ACCESS REPORT

DEVELOPMENT APPLICATION

“SITE 9”

**3 OLYMPIC BOULEVARD
CNR SARAH DURACK AVENUE
SYDNEY OLYMPIC PARK**

External Pathway Links and Building Entrances (Parts D3.2 & D3.3 of the BCA)

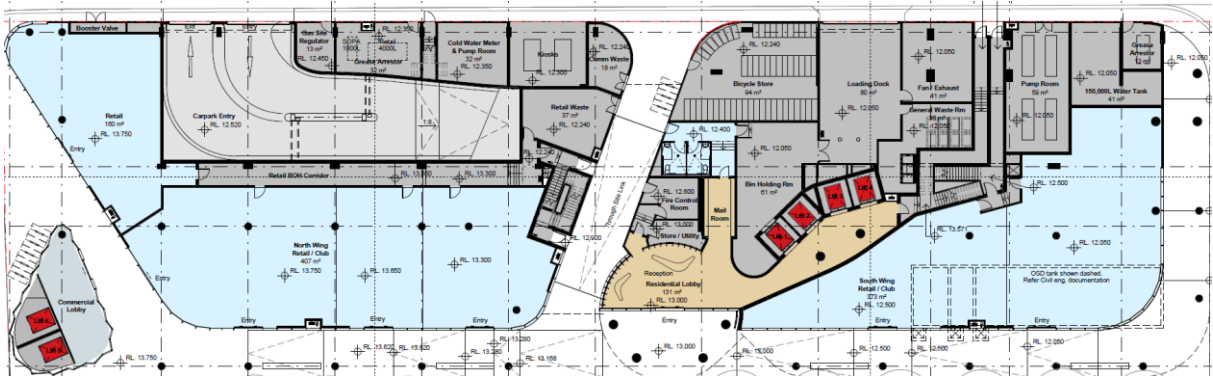
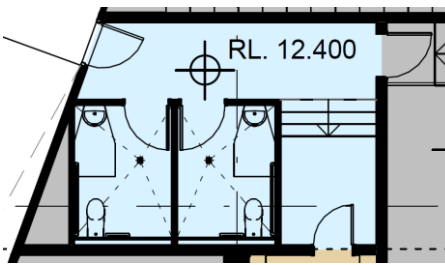
BCA / DDA Access Code Review		Complies
1. Retail Entrances – The development proposes several retail tenancies on the ground floor at varying finished floor levels which reflect the topography of the adjacent public domain footpath along the Olympic Boulevard to enable level doorway thresholds to ensure equitable access to and within all areas consistent with the DDA Premises Standards and Part D3.2 of the BCA.		YES

2. Entry Doors to the various tenancies shall be confirmed at a future design stage to provide 850mm minimum clear opening width with doorway luminance contrast and other features as specified by AS1428.1 to satisfy D3.2 and Table D3.1 of the BCA, DDA Premises Standards and the SOP Access Guidelines.		YES

3. Commercial Entry Lobby – The development proposes a level threshold entrance to the common residential lobby through an auto sliding doorway which facilitates universal access that complies with AS1428.1 to satisfy D3.2 and Table D3.1 of the BCA and the SOP Access Guidelines.		YES

4. Common Residential Entry Lobby – The development proposes a level threshold entrance to the common residential lobby @RL13.00 through an auto		YES

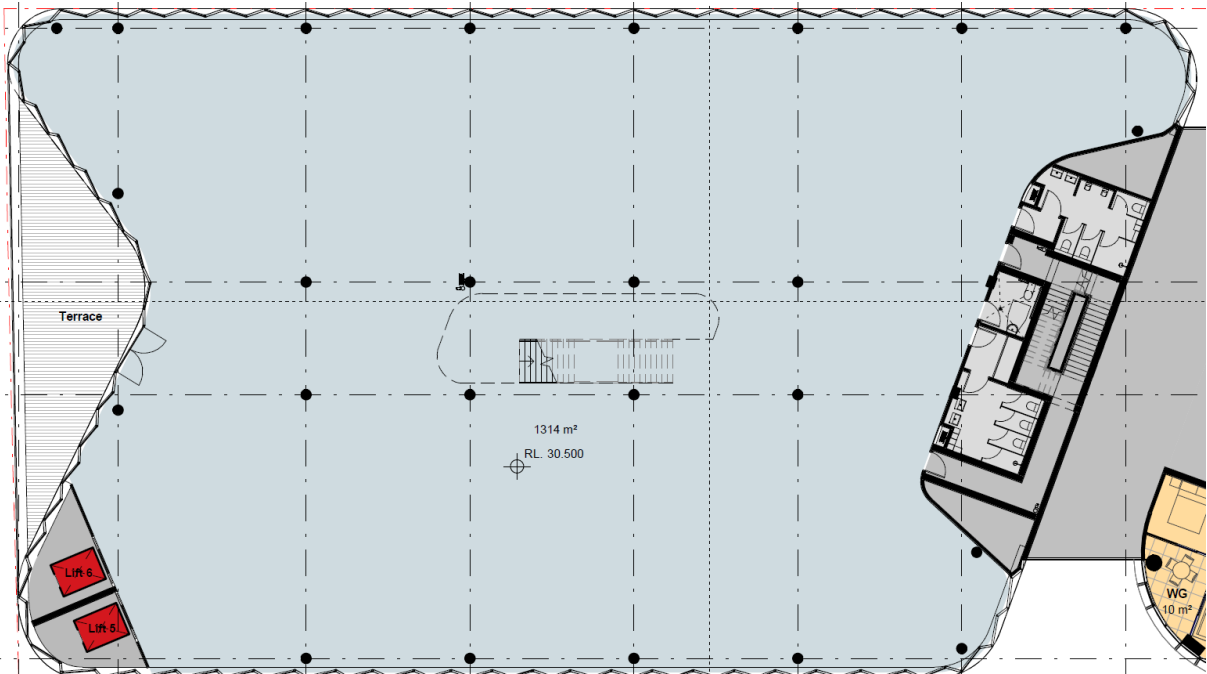
5. Lift Access – The internal areas of the lift lobbies propose level floor areas with direct access to lift landings that provide ample circulation spaces for Turning and Passing that comply with AS1428.1 and readily satisfy Parts D3.3 and E3.5 of the BCA and DDA Premises Standards.	YES

6. The multiple lifts travel to all parking, commercial and residential levels and consequently to the doorway entrances of all apartments to comply with Table D3.1 of the BCA, the DDA Premises Standards and the SOP Access Guidelines.	YES

7. The lifts will provide a minimum of 1400 X 2000mm lift cars and will be detailed to comply with all aspects of Part E3.6 of the BCA and the DDA Premises Standards.	YES

8. Through Site Link – The development proposes a public through site link that will provide a moderate 1:20 slope from RL21.900 to RL12.400 and will facilitate access to the common accessible toilets and bike storage room and subject to a minor adjustment of the walkway to ensure a 510mm minimum offset from the common toilets access door then the through site link will fully comply with AS1428.1 and satisfy Part D3.3 of the BCA, DDA Premises Standards and the SOP Access Guidelines.	YES

9. Common Area Accessible Toilets - In addition to the provision of accessible principal building entrances the development proposes common sanitary facilities on the ground floor that can be accessed by all retail tenancies and visitors to the residential component of the development. The plans show two wheelchair accessible toilets that will comply with AS1428.1 and satisfy Parts D3.3, F2.4 of the BCA, DDA Premises Standards and the SOP Access Guidelines.	YES

Parking (Part D3.5 of the BCA)

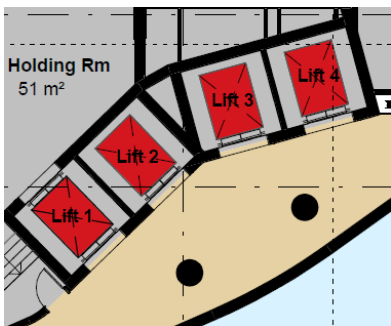
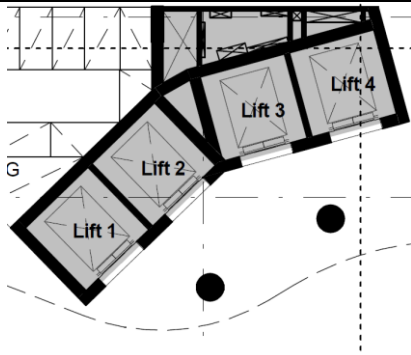
BCA / DDA Access Code Review	Complies
10. The development proposes 49 retail/commercial car spaces with at least 5 accessible parking spaces, which provide 2400mm width adjoining 2400mm width shared areas while the carpark will have 2200mm minimum entry and aisle height clearances on level areas in accordance with AS2890.6 to satisfy Part D3.5 of the BCA, the DDA Premises Standards and the SOP Access Guidelines.	YES
11. Level 2 provides (1) accessible retail space and (1) accessible visitor space with level access to the common lifts which travel to the ground floor retail and the residential apartment levels.	YES
12. Level 3 provides (1) accessible retail space and (2) accessible commercial spaces with level access to the common lifts which travel to the ground floor retail and the residential apartment levels.	YES

Internal Accessways (Part D3.3 of the BCA)

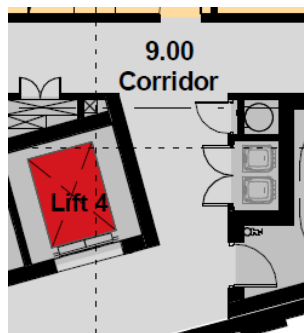
BCA / DDA Access Code Review		Complies
Retail 		
13. The ground floor retail areas provide open plan areas over multiple levels consistent with the street level entrances. 14. North Wing Retail - The internal circulation spaces within the tenancy shall be at the same level as the entry and will facilitate Turning and Passing Areas in accordance with AS1428.1 to satisfy part D3.3 of the BCA and DDA Premises Standards. 15. North Wing Retail/Club – The overall area indicates three entrances and three internal floor levels that correlate at the same levels to achieve internal circulation spaces, Turning and Passing in accordance with AS1428.1 to satisfy part D3.3 of the BCA and DDA Premises Standards. 16. South Wing Retail/Club – The overall area indicates two entrances and two internal floor levels that correlate at the same levels to achieve internal circulation spaces, Turning and Passing in accordance with AS1428.1 to satisfy part D3.3 of the BCA and DDA Premises Standards. 17. Where two or more areas are aggregated into a larger tenancy the fitout shall require the detailing or ramps or lifts to facilitate access to all areas.		YES YES YES

18. Common Area Accessible Toilets - The development proposes two wheelchair accessible common toilets on the ground floor that can be accessed by all retail tenancies and visitors to the residential component of the development, albeit the accessible pathway is external to the building. The two toilets will comply with AS1428.1 and satisfy Parts D3.3, F2.4 of the BCA, DDA Premises Standards and the SOP Access Guidelines.		YES

19. Doors & Doorway Luminance Contrast – Doors shall generally be 920mm minimum leaves to ensure 850mm minimum clearance, include lever handles at 900-1100mm height and be of a colour that provides at least 30% luminance		Yes at CC Stage

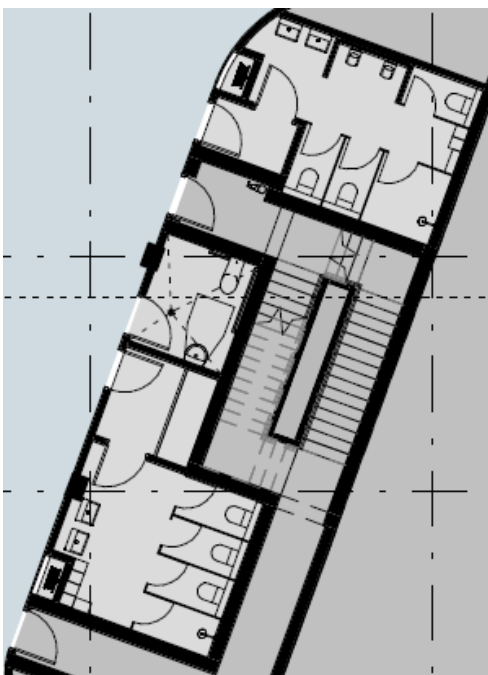
BCA & SOP Access Guideline Review	Complies
29. At the southern end of the lifts the plans propose 1600mm minimum width corridors which facilitate direct access to all apartment entrance doorways and facilitate Turning Areas in accordance with AS1428.1 while the T-junction facilitates Passing Areas to satisfy Part D3.3 of the BCA and the SOP Access Guidelines. 30. At Level 09 the plans propose the northern corridor shall continue to a Common Room and the outdoor common area roof terrace via a 1600mm minimum width corridor which facilitates level access and complying doorway circulation spaces to ensure equitable access in accordance with AS1428.1 to satisfy Part D3.3 of the BCA and the SOP Access Guidelines. 	YES YES

31. Level 9 Common Room – The level 9 Common Room design confirms doorway and internal circulation spaces to and within complying with AS1428.1 to satisfy Part D3.3 and Table D3.1 of the BCA and the SOP Access Guidelines. 	YES

32. Level 9 Common Outdoor Terrace - The level 9 plan shows an outdoor communal terrace garden area at the same level as the common lift lobby area	YES

Tactile ground surface indicators (Part D3.8 of the BCA)

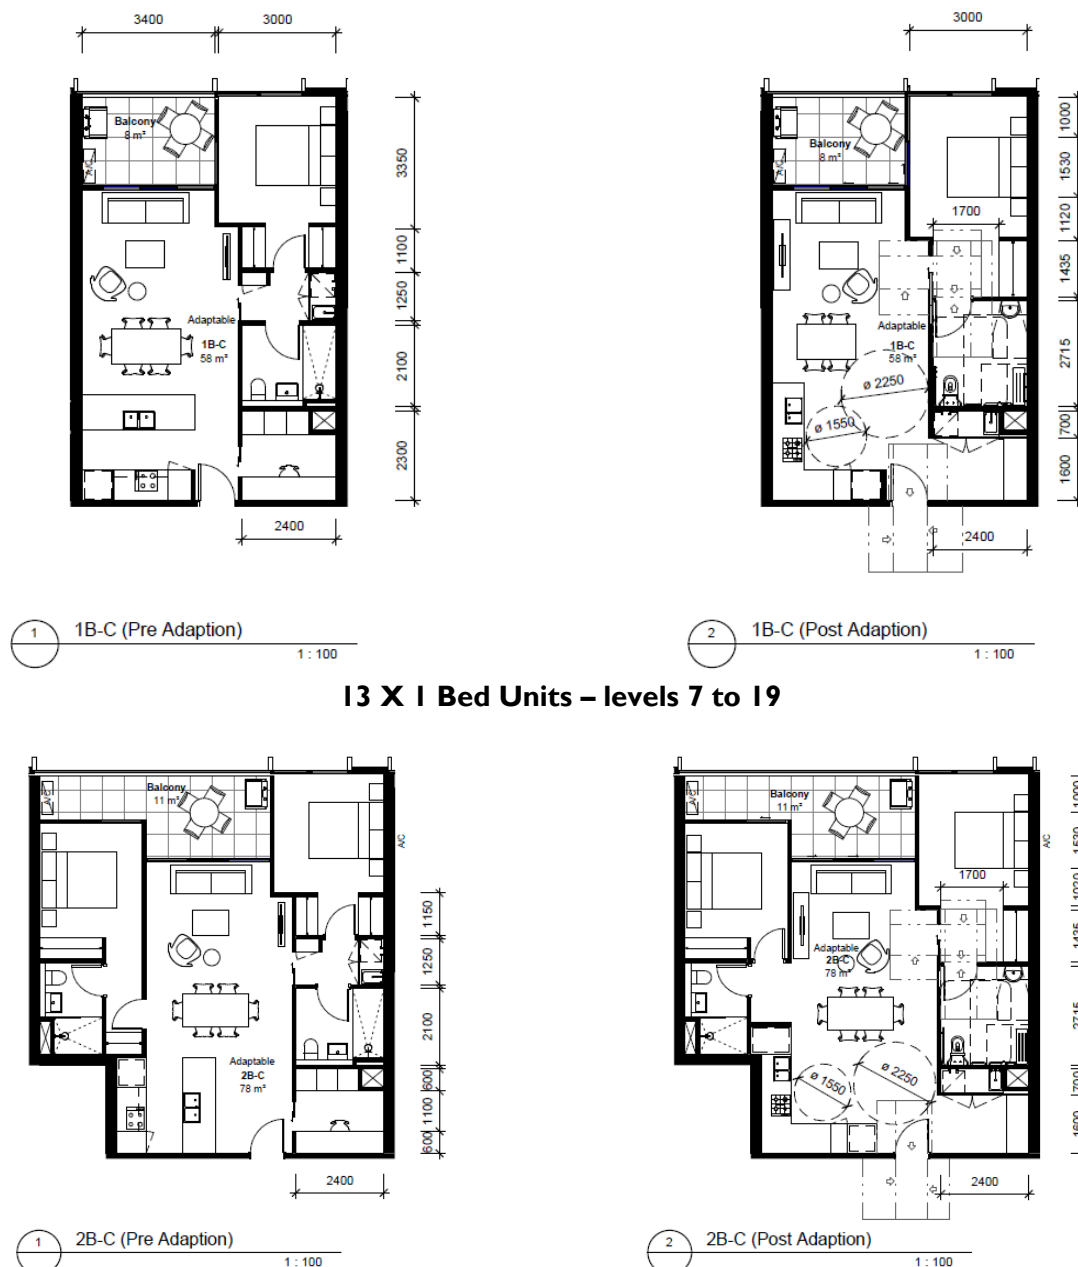
BCA / DDA Access Code Review		Complies
47. There are several ramps or stairways within the development that require tactile ground surface indicators (TGSI's) including; a) Mailroom stairway on the ground floors. b) Stairway linking the level 8 and 9 commercial areas would be subject of the fitout of interior finishes.		YES at CC stage

1 4B-A (Pre Adaption)

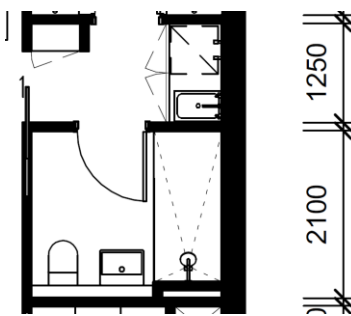
AS4299 Clause 4.6	Main bedroom – The plans show a main bedroom for the adaptable units that can be adapted to provide; • 3000mm X 3650mm plus an ante entry/walkthrough robe area of 1435 X 1700 for the 1 bedroom design. • 3000mm X 3550mm plus an ante entry/walkthrough robe area of 1435 X 1700 for the 2 bedroom design. • 3400mm X 3550mm plus an ante entry/walkthrough robe area of 1550 X 1270 for the 4 bedroom design. The abovementioned areas can be achieved by modifying wardrobe locations which allows a circulation area of 1540mm X 2070mm clear of a queen sized bed and in front of the wardrobe while maintaining at least 1000mm clearance at the blind side and 1000mm at the foot of the bed to satisfy AS4299.	YES YES YES
AS4299 Clause 4.7	Bathroom – The plans show that the bathrooms will be at least 2700mm X 2400mm, which enables compliance with AS1428 in terms of spatial area. To facilitate adaptation to an accessible unit the toilet pan, washbasin and shower shall require some adjustment of the pre-adaptation locations to satisfy the performance requirements of AS4299.	YES
